Project:
NEW MULTI DWELLING
1044-1054 HOWARD
WINDSOR ONTARIO
OWNER

Drawing Title:
MODIFIED SITE PLAN

Drawing No.
SP-2

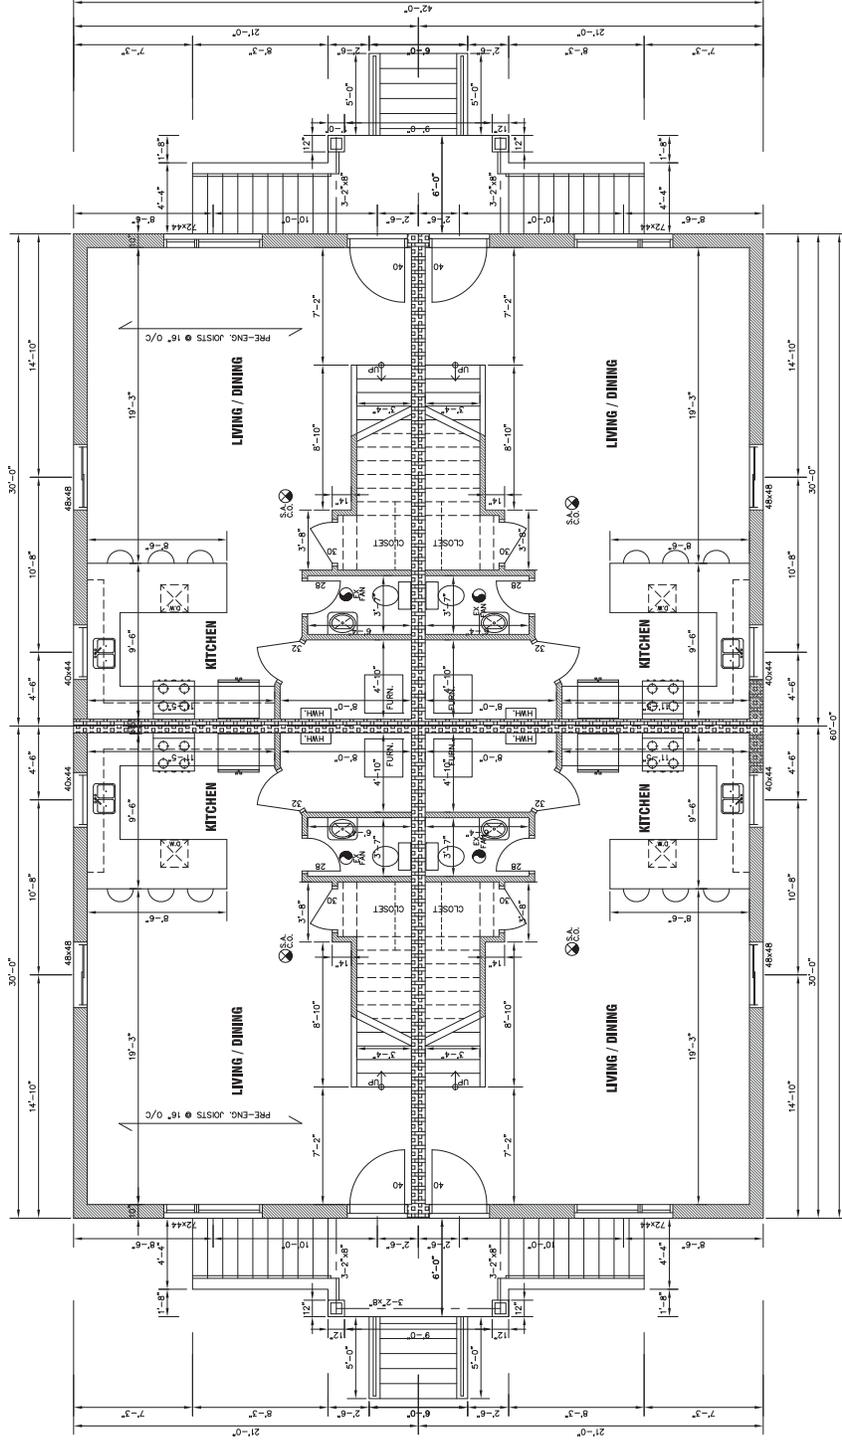
The City of Windsor Zoning By-law and Ontario Building Code were applied to this building with the understanding that the building will be used as a double duplex. If the intention is to create additional dwelling units in the basement then a zoning review and Ontario Building Code review will be required.

9.10.8.3. Fire-Resistance Ratings
All loadbearing walls, columns, and beams in the storey immediately below a floor or roof assembly shall have a fire-resistance rating of not less than that required for the supported floor or roof assembly.

Every floor level containing a bedroom shall be provided with at least one outside window that is operable from the inside without the use of tools and maintains the required opening without the need for additional support. Except for basement areas, the window shall have a maximum sill height of 1000 mm above the floor.

Loadbearing interior walls at right angles to floor joists shall be located not more than 900 mm from the joist support when the wall does not support a floor, and not more than 600 mm from the joist support when the wall supports one or more floors, unless the joist size is designed to support such loads.

Covers for sump pits shall be designed to resist removal by children and sealed in accordance with 9.25.3.3.(16). OBC

SECOND FLOOR PLAN

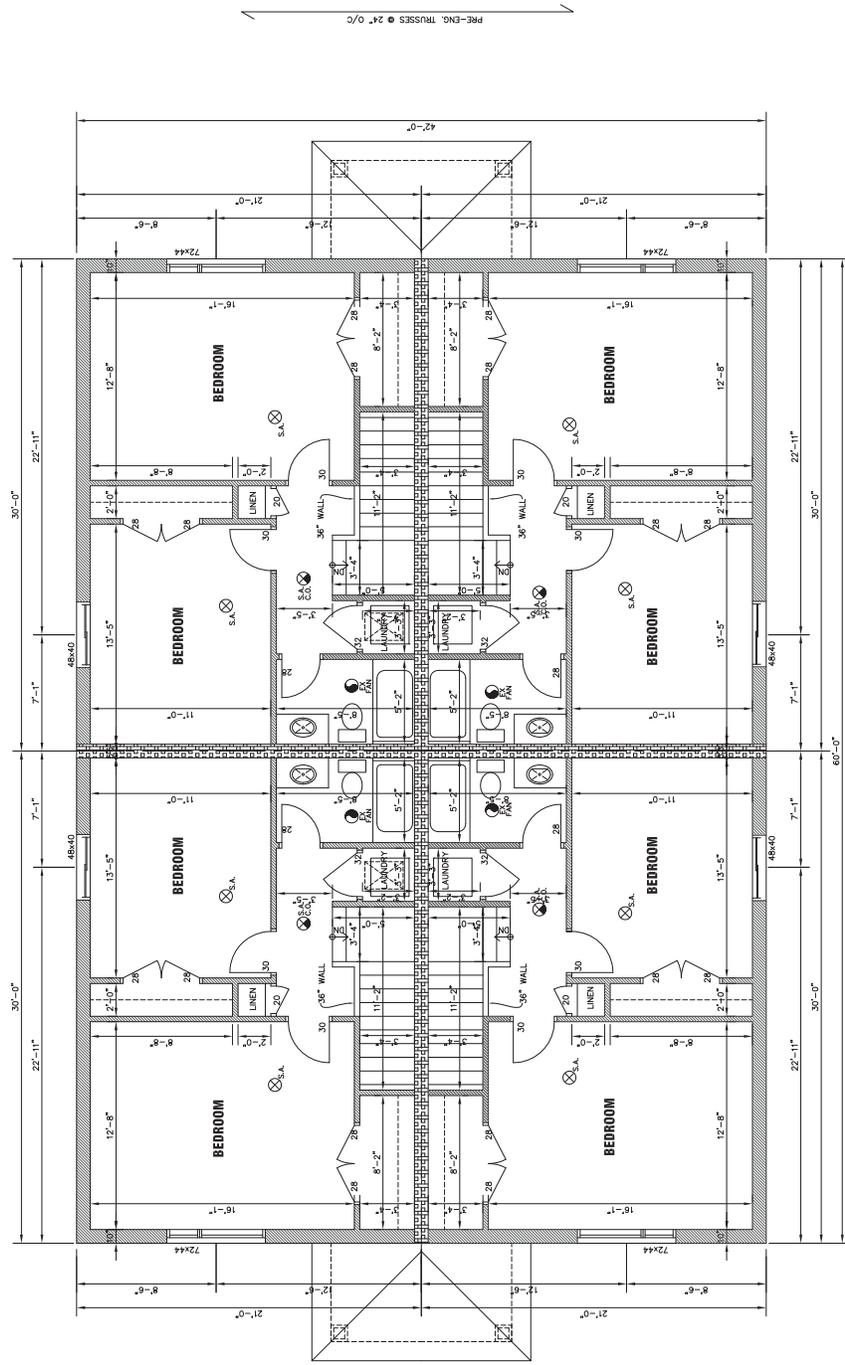
SA Interconnected smoke alarms shall be located on each storey, including basements, in each sleeping room and in the hallway serving the sleeping rooms, have a visual component and be on battery backup. CO An interconnected carbon monoxide alarm shall be installed adjacent to each sleeping area.

A furnace serving a house shall be equipped with a brushless direct current motor. 12.3.1.5. OBC

Clothes dryer and exhaust fans shall exhaust directly to the exterior. The ductwork for the kitchen hood shall be noncombustible, corrosion-resistant, and be equipped with a grease filter at the intake.

9.10.8.3. Fire-Resistance Ratings
All loadbearing walls, columns, and beams in the storey immediately below a floor or roof assembly shall have a fire-resistance rating of not less than that required for the supported floor or roof assembly.

9.31.4.2. Laundry Fixtures
(1) Laundry facilities or a space for laundry facilities shall be provided in every dwelling unit or grouped elsewhere in the building in a location conveniently accessible to occupants of every dwelling unit.

Provide stairs, guards, handrails, and a landing conforming to 9.8. OBC.

Vertical Clearances Above Cooktops shall comply with 9.10.22.2. OBC.
Protection Around Cooktops shall comply with 9.10.22.3. OBC.

BASEMENT PLAN

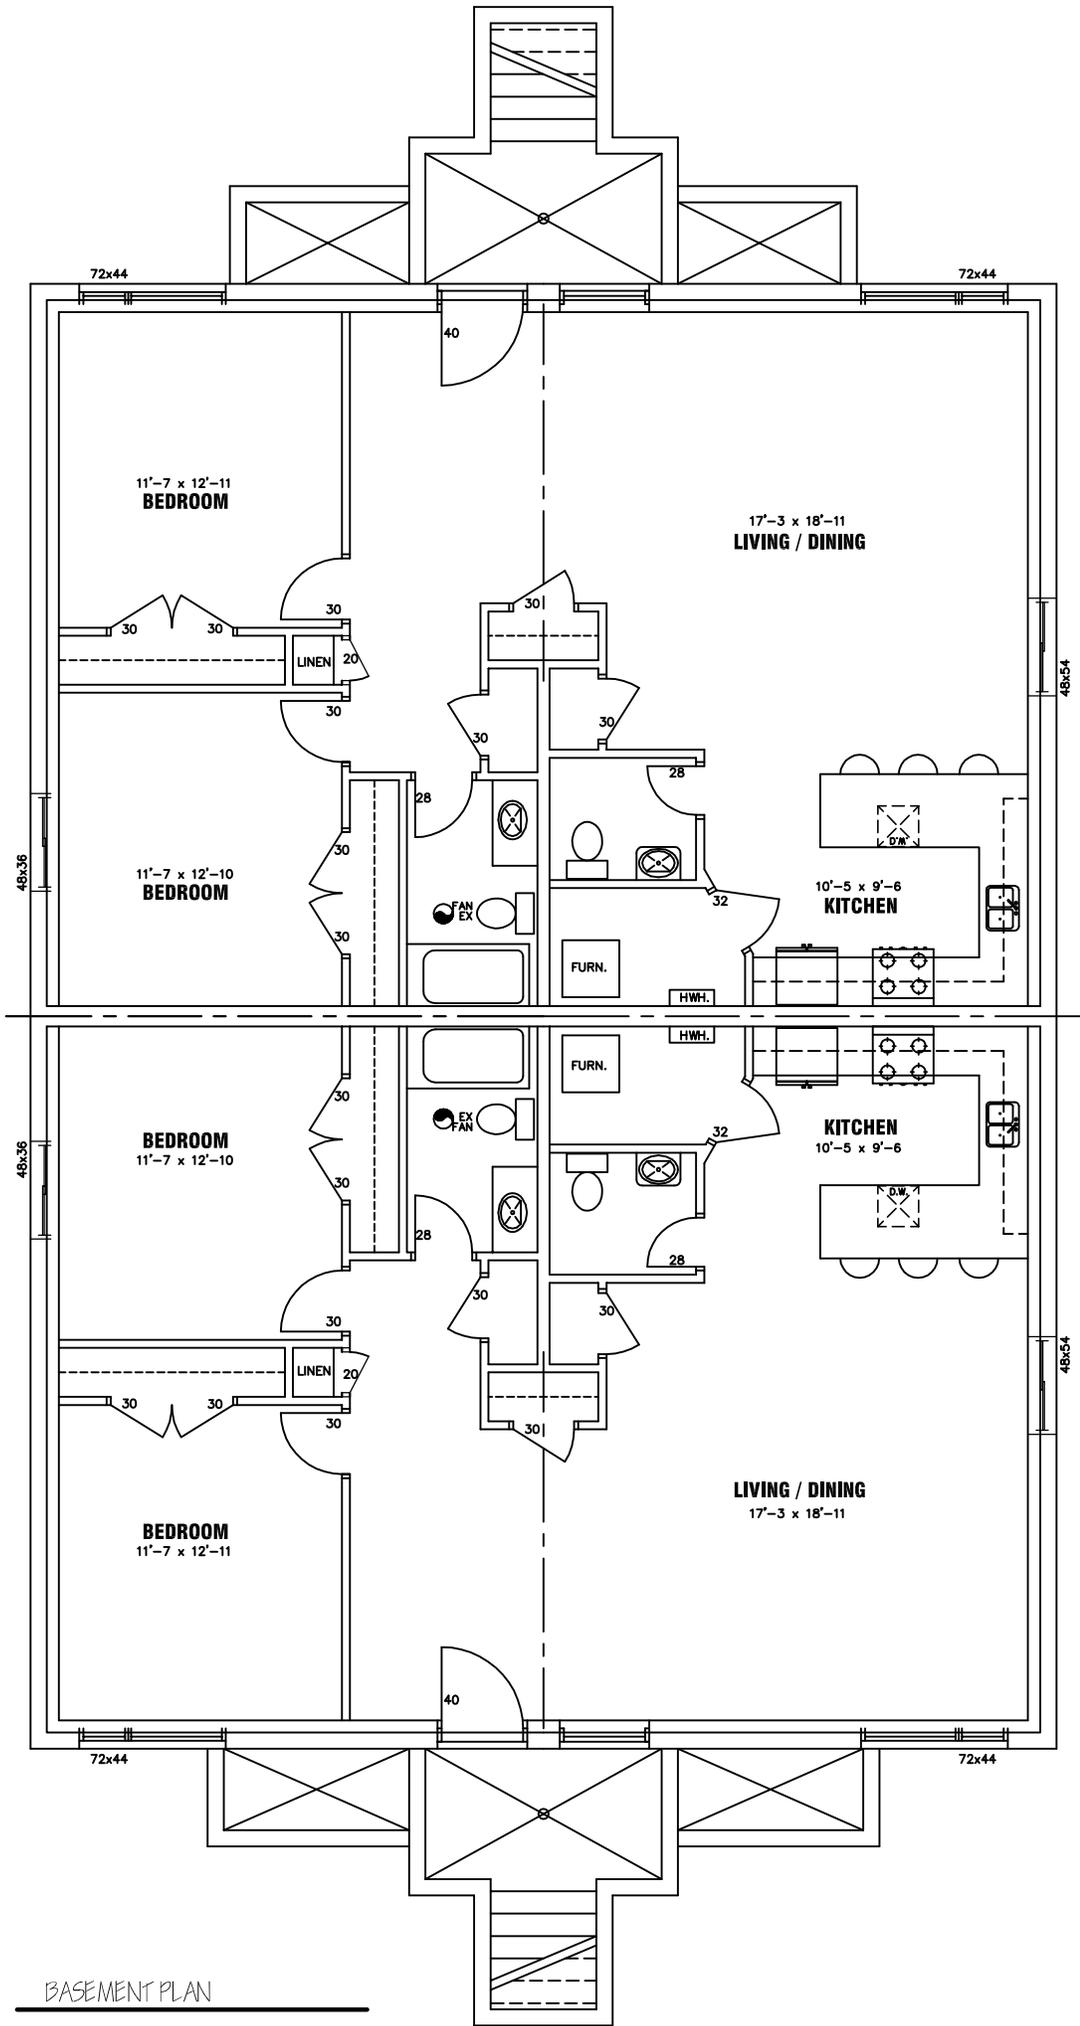
A furnace serving a house shall be equipped with a brushless direct current motor. 12.3.1.5. OBC

Every attic or roof space shall be provided with an access hatch not less than 0.32 m2 in area with no dimension less than 545 mm, or 500 mm by 700 mm.

BACK ELEVATION

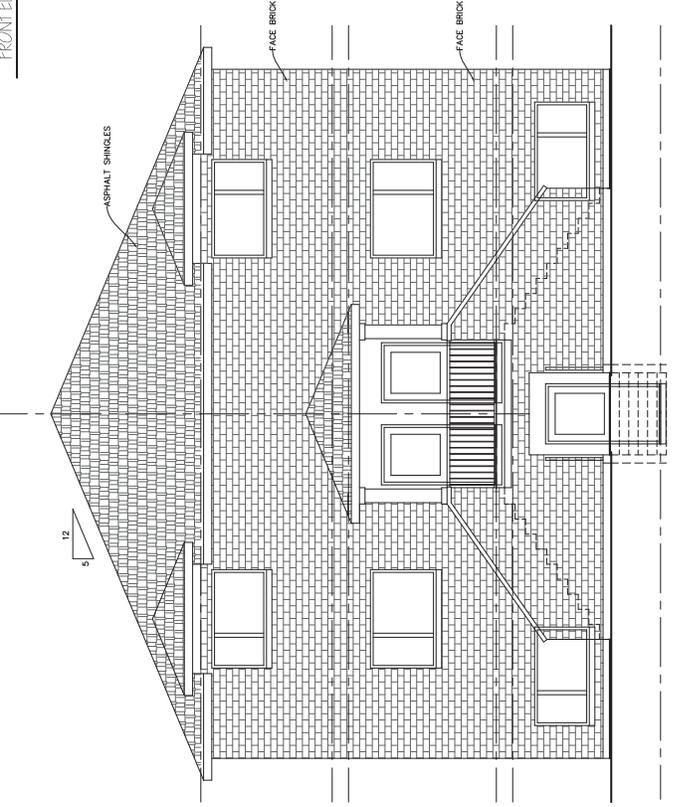
Downspouts adjacent to hardscape surfaces are to be extended underground to pop up drainage emitters (NDS) that discharge onto landscaped areas. Maintain a 2 ft clearance from all hard surfaces.

Main entrance doors to dwelling units shall be provided with: a door viewer, transparent glazing in the door or a sidelight, a deadbolt, and an exterior lighting outlet with fixture controlled by a wall switch located within the building.

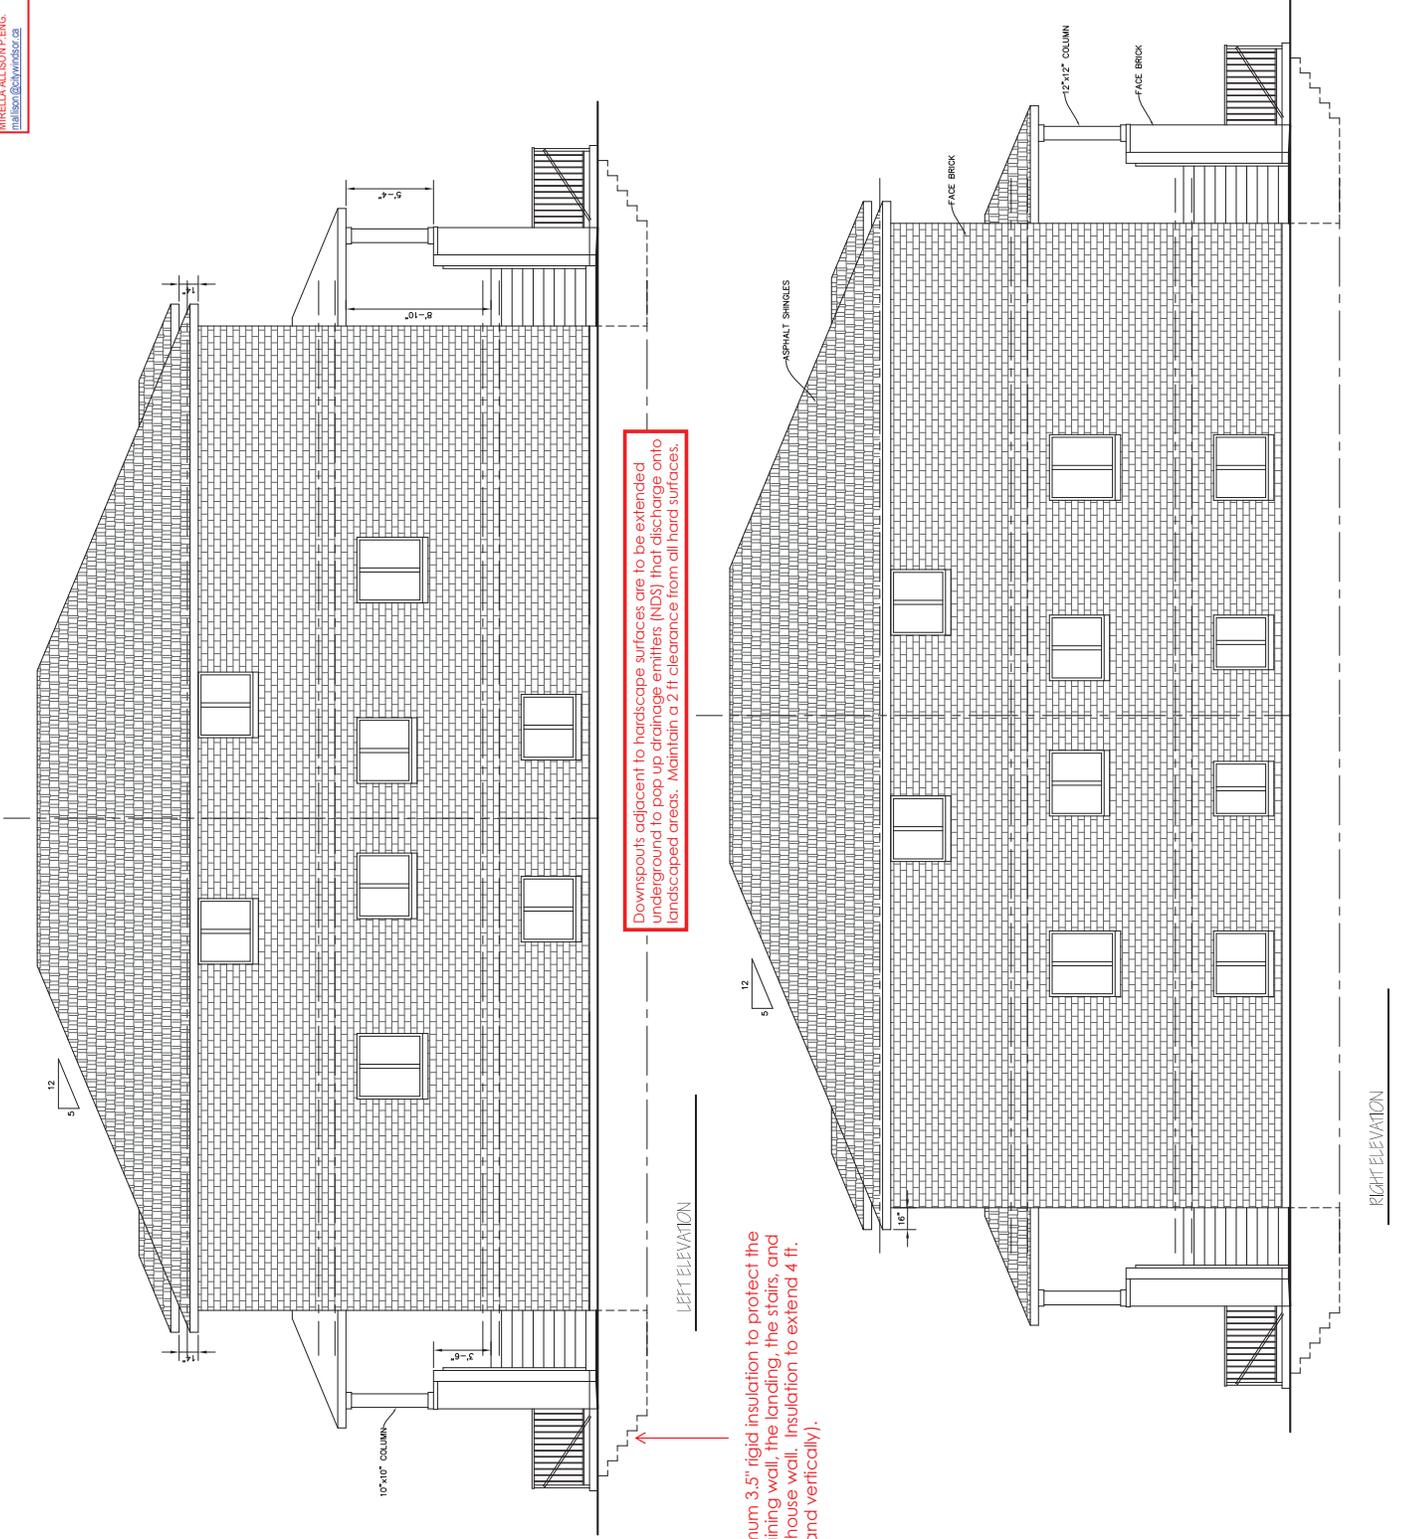
Downspouts adjacent to hardscape surfaces are to be extended underground to pop up drainage emitters (NDS) that discharge onto landscaped areas. Maintain a 2 ft clearance from all hard surfaces.

Provide minimum 3.5" rigid insulation to protect the exposed retaining wall, the landing, the stairs, and the exposed house wall. Insulation to extend 4 ft. (horizontally and vertically).
